# HISTORIC AND DESIGN REVIEW COMMISSION

**HDRC CASE NO:** 2023-370  
**ADDRESS:** 419 KALTEYER ST  
**LEGAL DESCRIPTION:** NCB 6515 BLK 4 LOT 18  
**ZONING:** R-4, H  
**CITY COUNCIL DIST.:** 3  
**DISTRICT:** Mission Historic District  
**APPLICANT:** Ammon Farzampour/Personal  
**OWNER:** GARZA RODOLFO  
**TYPE OF WORK:** New construction of a 1-story, single-family structure  
**APPLICATION RECEIVED:** August 29, 2023  
**60-DAY REVIEW:** October 28, 2023  
**CASE MANAGER:** Rachel Rettaliata

The applicant is requesting a Certificate of Appropriateness for approval to construct a 1-story, single-family residential structure on the vacant lot at 419 Kalteyer, located within the Mission Historic District.

ROOF PLAN

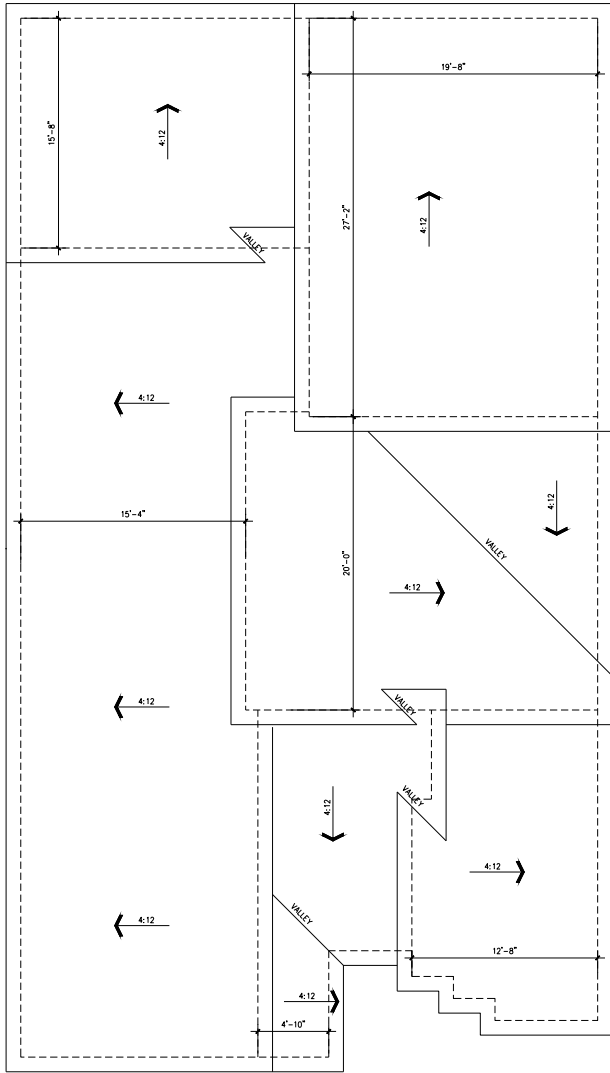
- ii. That the applicant greatly simplifies the proposed roof forms and submits updated plans and elevation drawings for staff review and approval prior to returning to the HDRC based on finding i. A structure featuring one traditional primary roof form and one traditional secondary roof form would be most appropriate.
